**RE: Retreat at PrairieRidge Filing 2 / Transportation Memorandum
El Paso County, Colorado
PCD File No. 259**

V2_Traffic Impact Study.pdf Markup Summary

Figure 2
PRELIMINARY PLAN

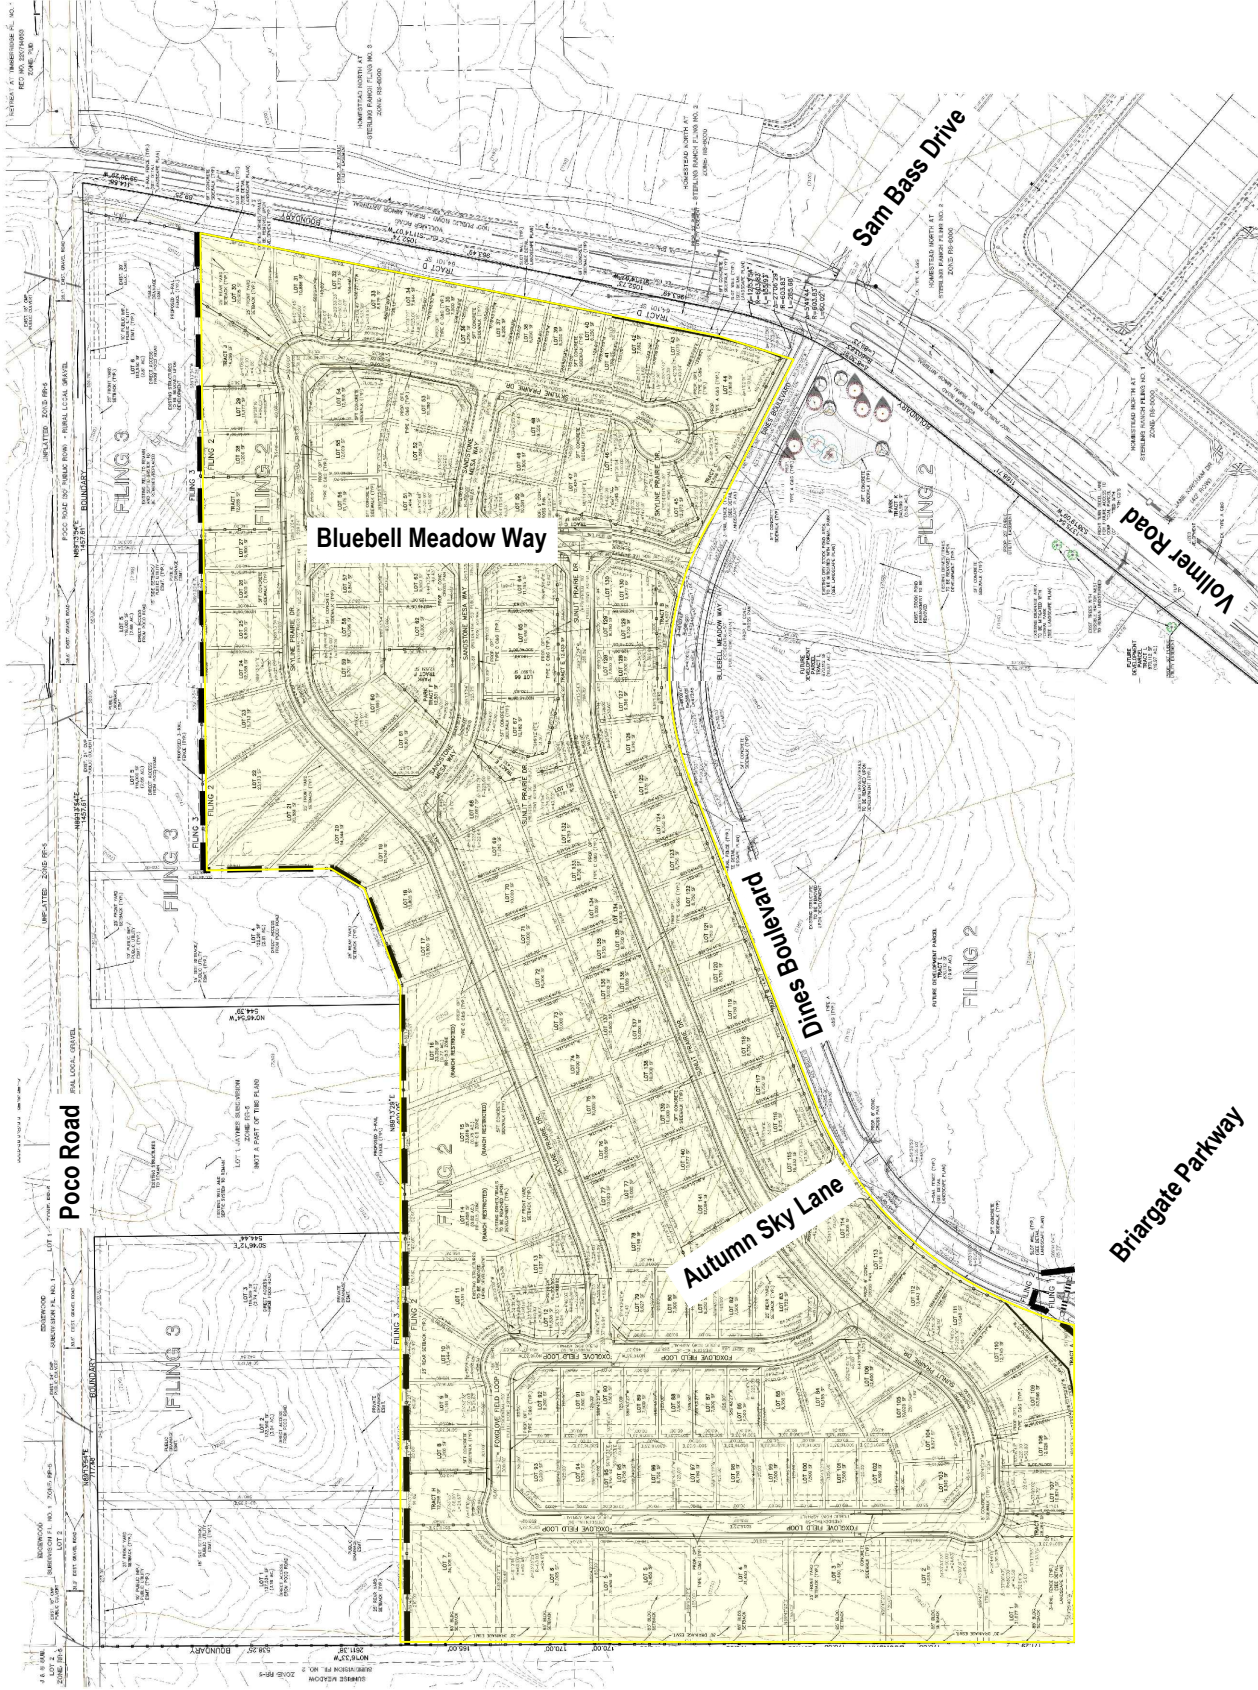
State what the access spacing and sight distance is. Please provide copy of exhibit in appendix.

State what the access spacing and sight distance is. Please provide copy of exhibit in appendix.
